PLANT NAME: Kewaunee

November 6, 1974

Subject: Docket 50-305
Operating License DPR-43
Review of IAC and Appendix K Criteria ECCS Technical Specifications

FIGURE I

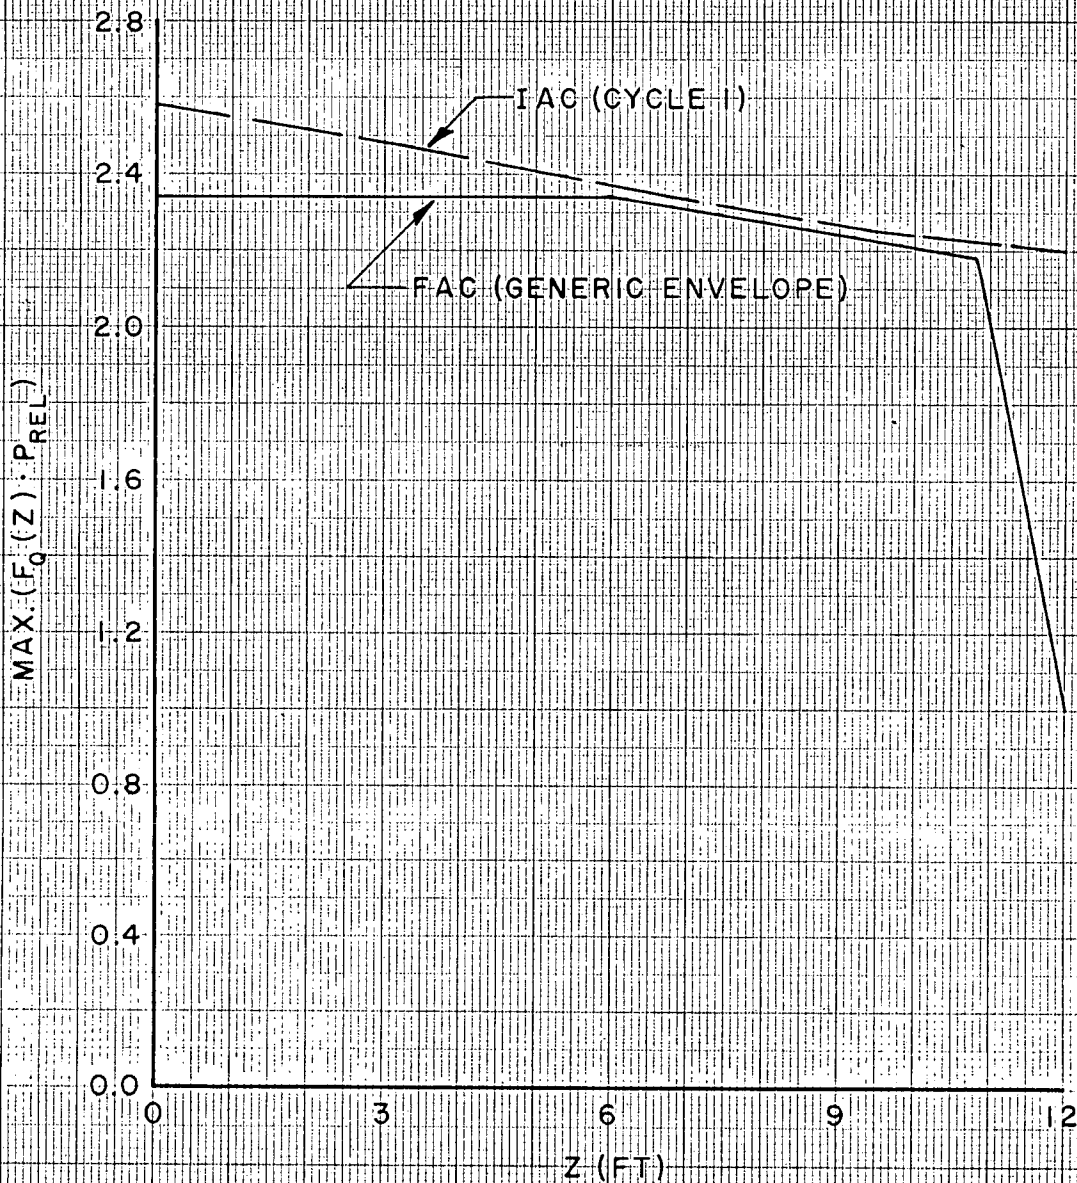
Our evaluation indicates that Fq limits should be in accordance with the attached plot (figure 1) at 100% power. This figure displays for Kewaunee the Fq constraints based on the following at 100% power:

- (a) IAC Tech. Specs., i.e. $\text{Max } (F_Q(Z) \cdot P_{\text{Rel}})_{\text{IAC}}$
- (b) FAC (Generic Envelope), which corresponds to the maximum expected $\text{Max } (F_Q(Z) \cdot P_{\text{Rel}})_{\text{IAC}}$ under Mode A/B operation.

Peaking factor limits below 100% power should be calculated on a case by case through comparison of the IAC and Appendix K Criteria Technical Specifications. Assuming the IAC technical specifications constraint on Fq to occur at all core elevations, the IAC technical specifications Fq constraints are placed on a consistent basis with the FAC technical specifications Fq constraints via:

$$\text{Max } (F_Q(Z) \cdot P_{\text{Rel}})_{\text{IAC}} = \frac{(\text{IAC Fq Constraint}) \cdot (1.03) \cdot (\text{Maximum Licensed Power})}{(\text{Densification Power Spike at Elevation Z})}$$
